Observation Report 04.02 – 11.02.2021

P2A/RF/RIM_TR3 – Rimex Panels installed out of tolerance Truss nr 5

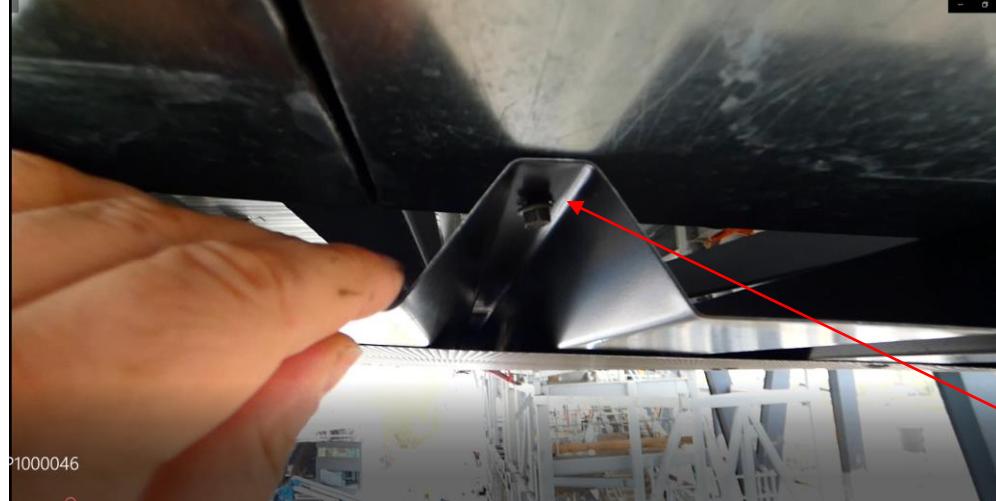
Backing Structure poor installed , rimex bowed and bailinear sheets loosed – please refer to video attached.

P2A/RF/RIM_TR5 – Galv backing structure and fixings not installed in line as per drawings

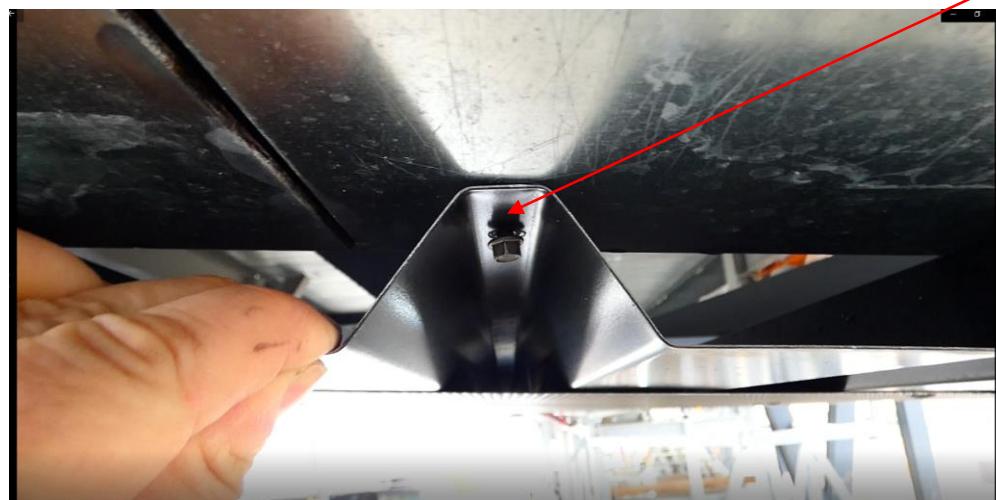
There is side wide issues where Kaicer do not follow drawings , in affect loose tolerance over 5mm on Rimex panels

AA Section A-A

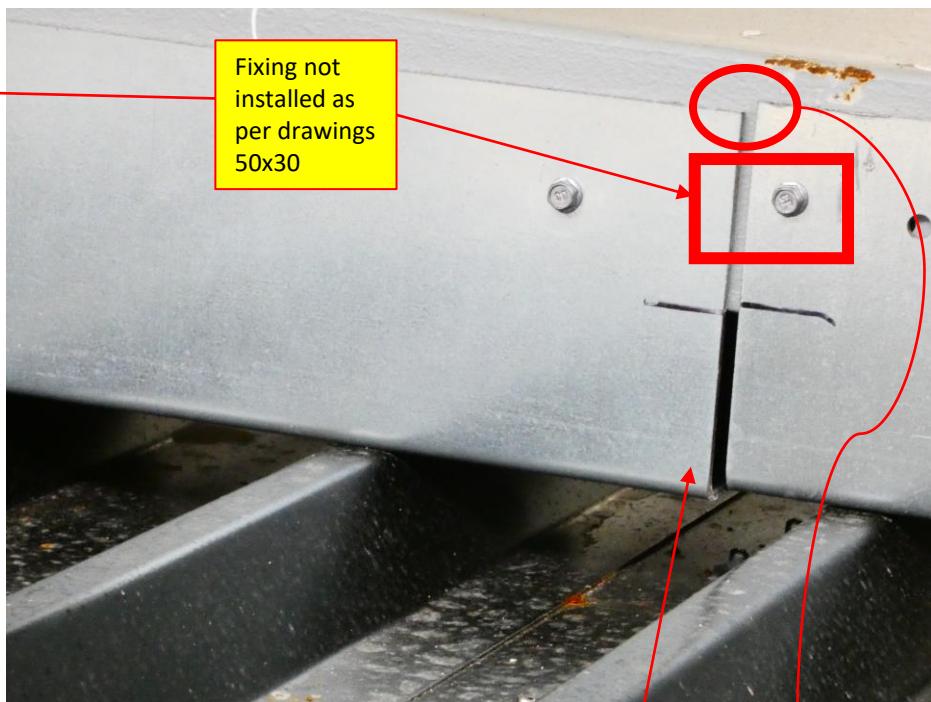
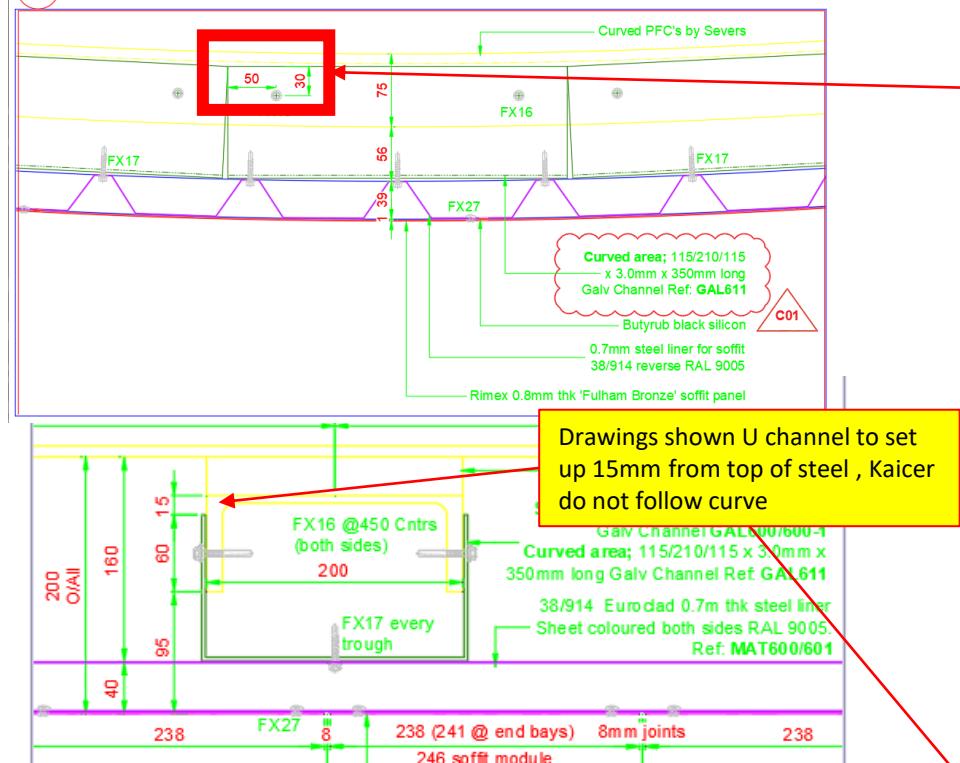
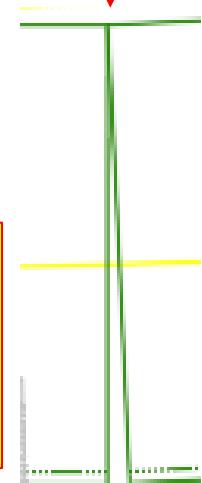
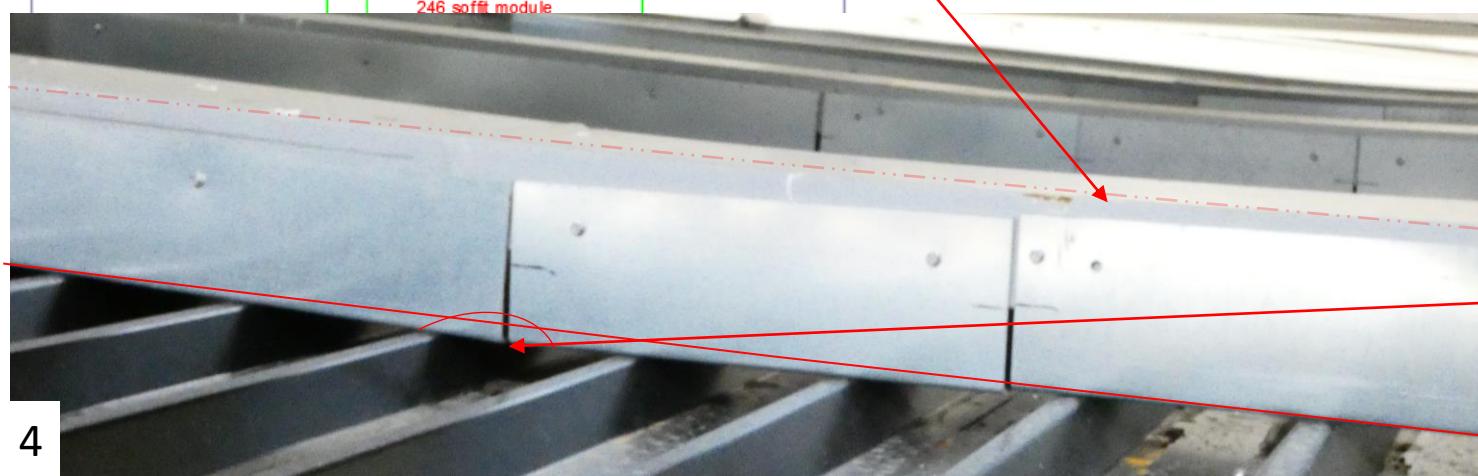
Step on Galv
Channels/not
installed as
per drawings
will affect
Linear and
Rimex Level

P3/RF/RIM_TR6 – Loose Fixings not Installed Correct

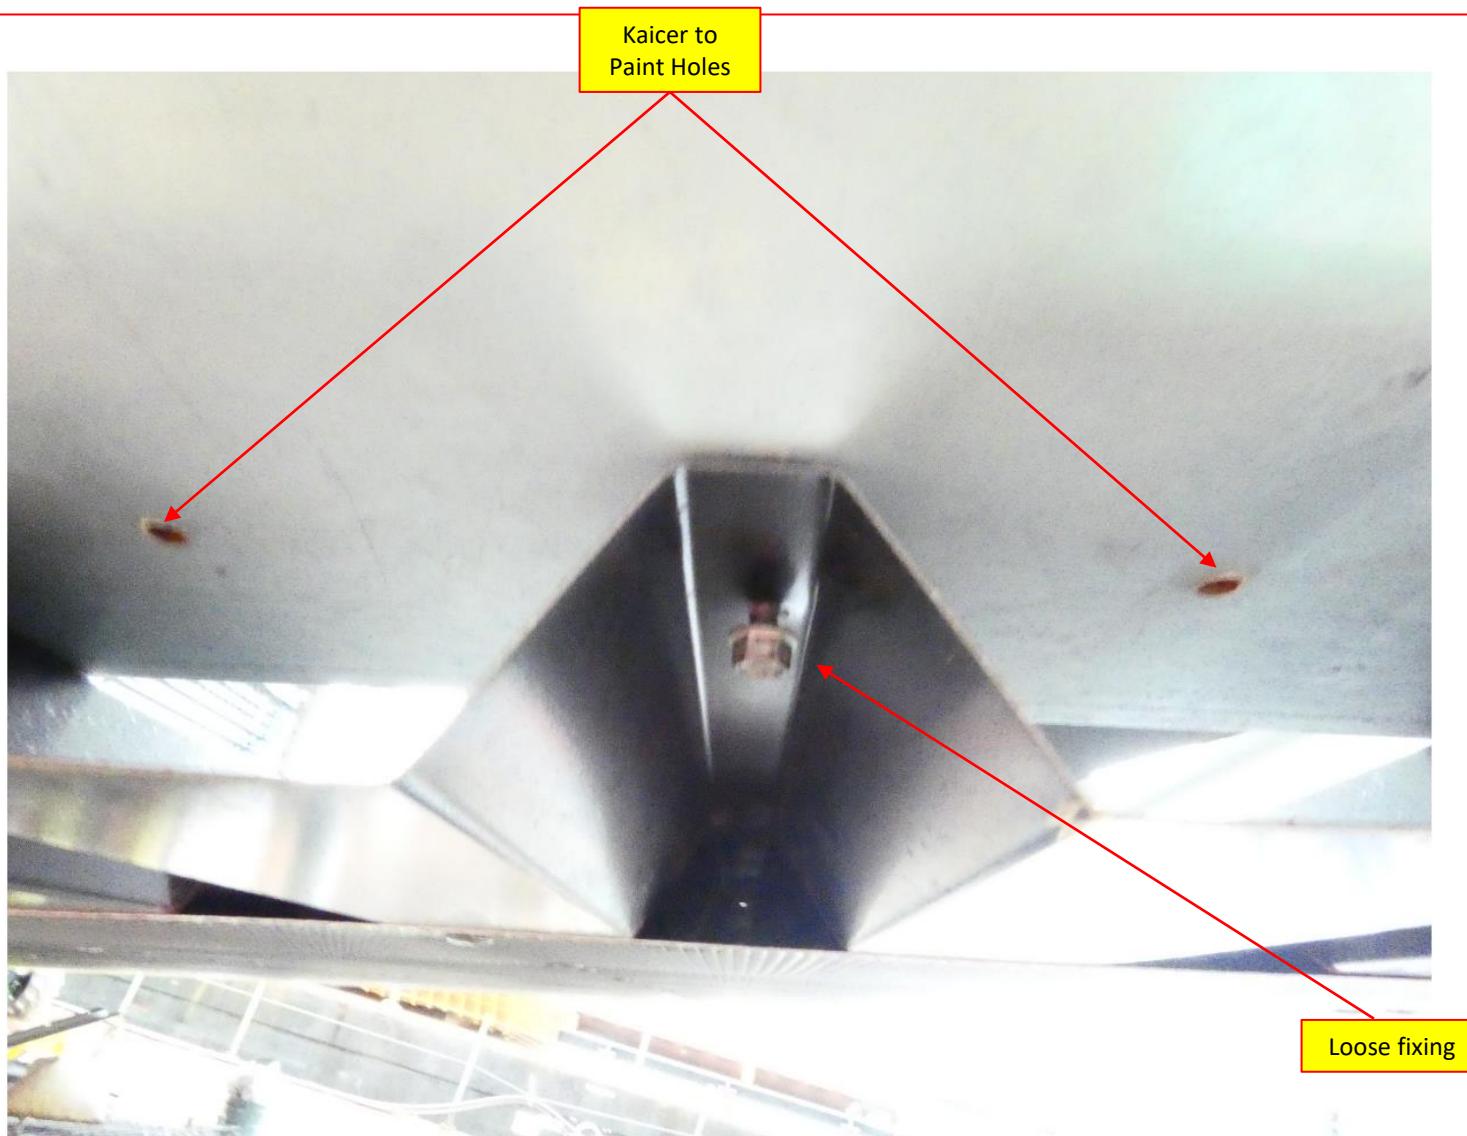
As per photo below, Kaicer to advise why this is site wide problem that fixings not installed correct

P3/RF/RIM_TR6 – Kaicer Miss Alignment and unwanted holes exposed

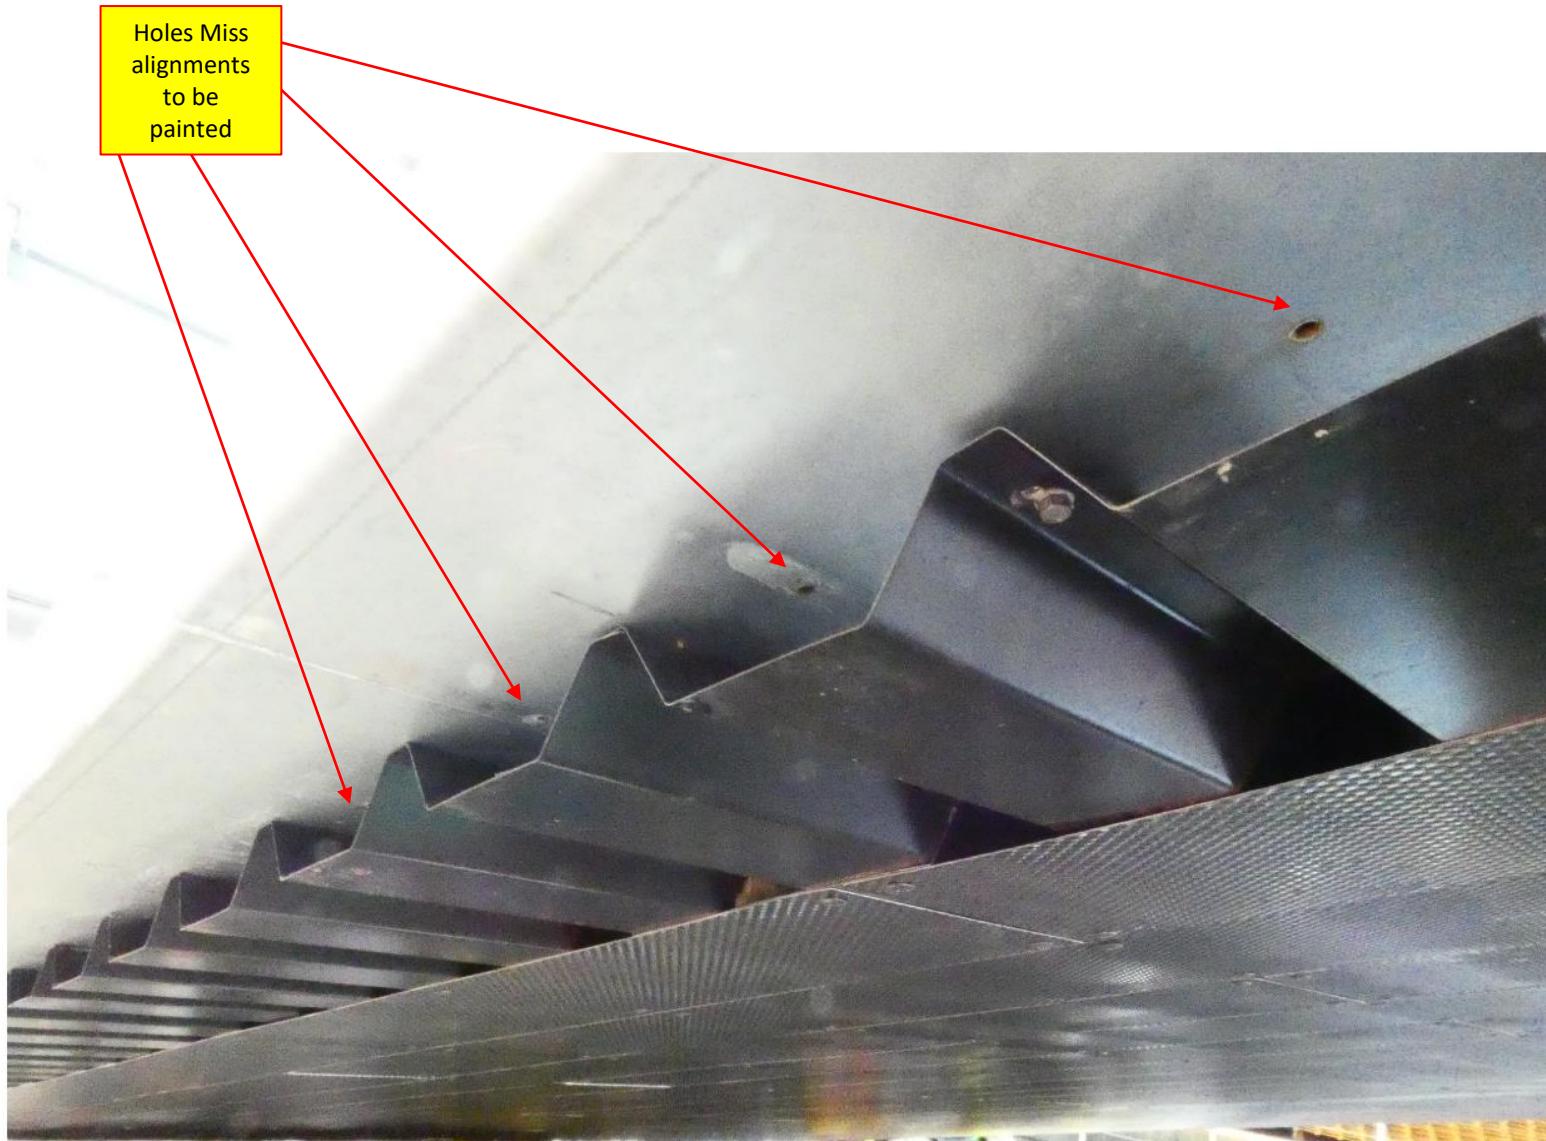
Holes on Galv channels to touch up against corrosion.

P1/RF/RIM_TR2 – Rimex Backing Structure Sheets poor Installed

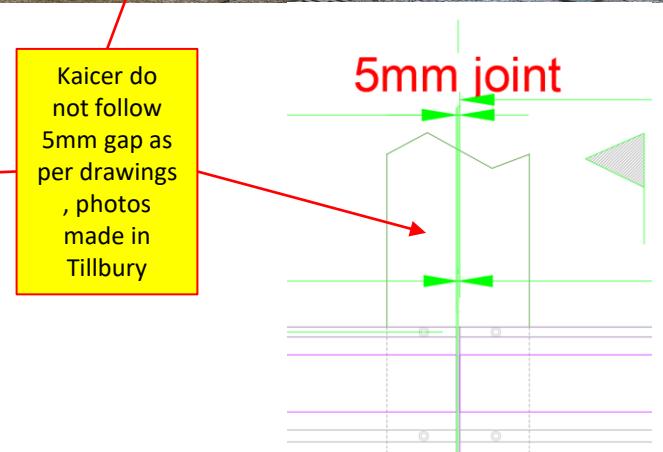
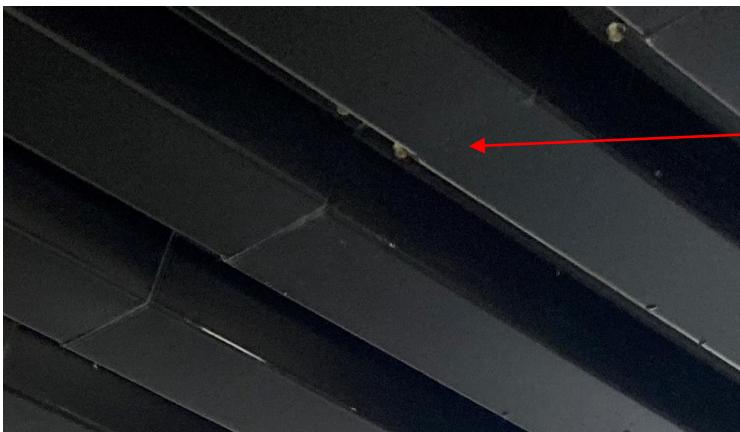
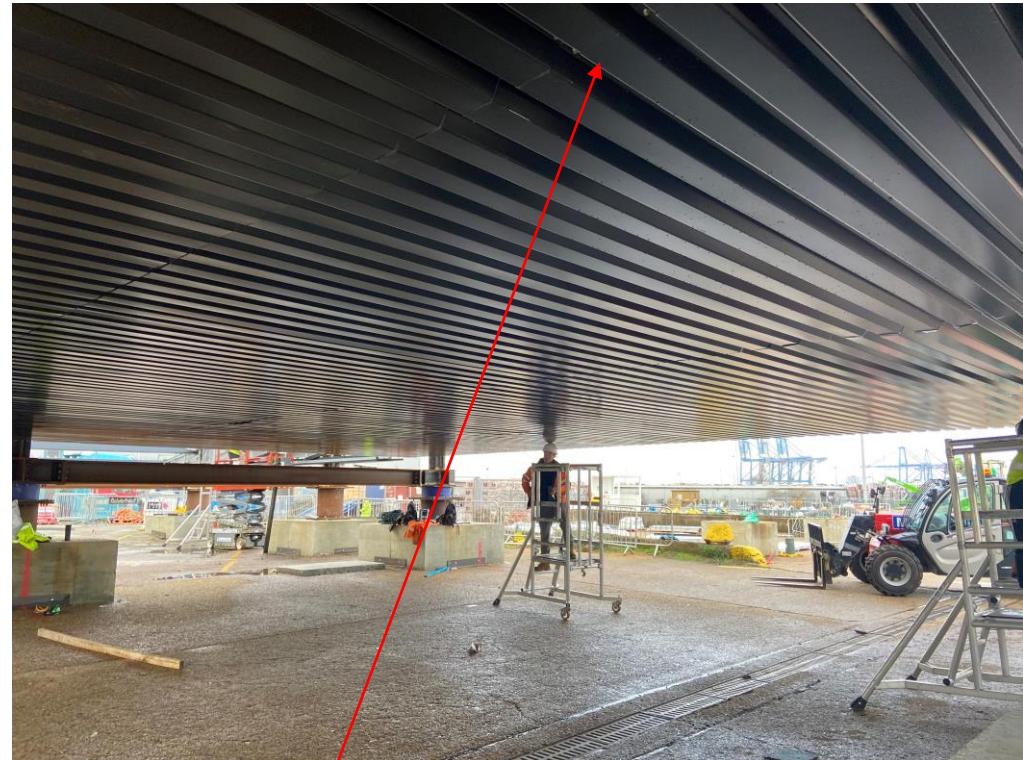
There is side wide issues where Kaicer do not follow drawings or fixings not installed correct.

Tillbury Truss – Defects on Rimex ,Visible from low angle view

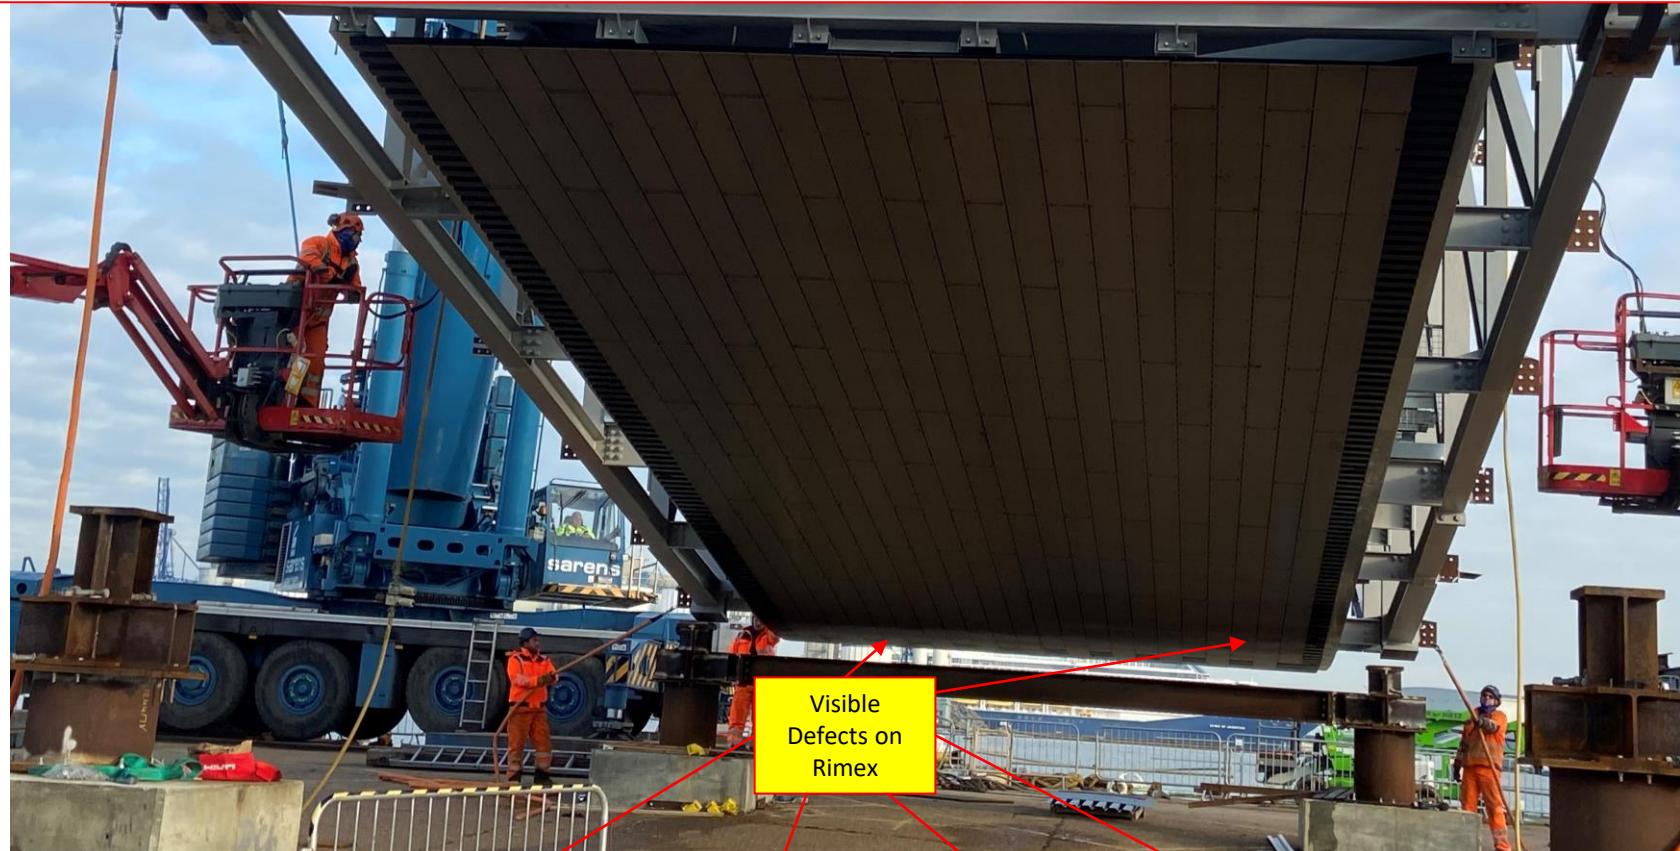
Photo made at Tillbury . Kaicer to advise why there rimex bows.

P3/RF/RIM_TR5 – Gap across Rimex panels

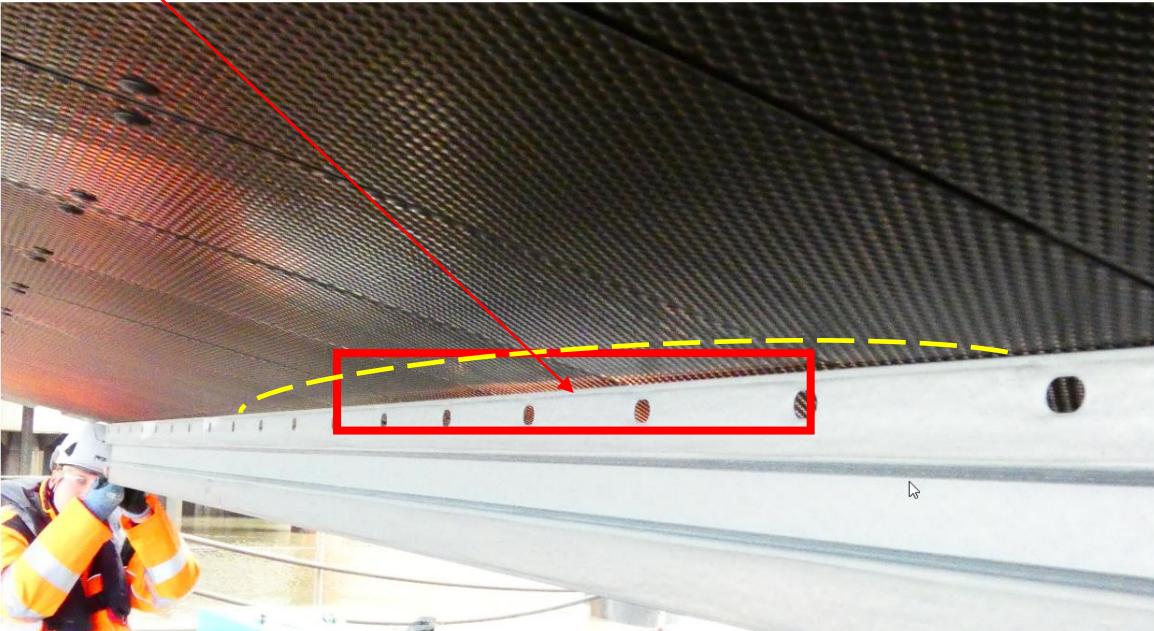
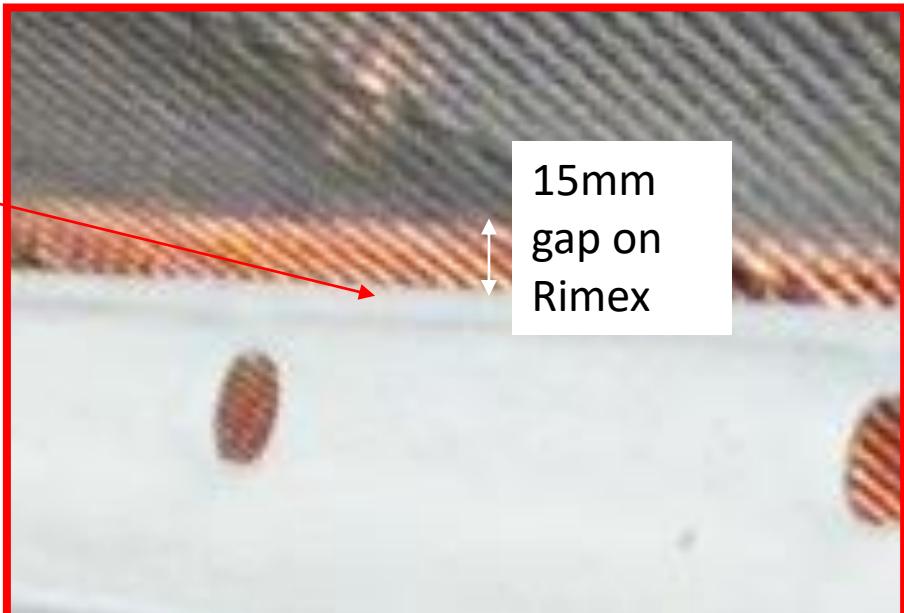
There is side wide issues where Kaicer do not follow drawings , in affect loose tolerance over 5mm on Rimex panels

- Short Bubble , allowed to transfer level from Galv to galv 1.47m only- there is possibility that level loose across truss
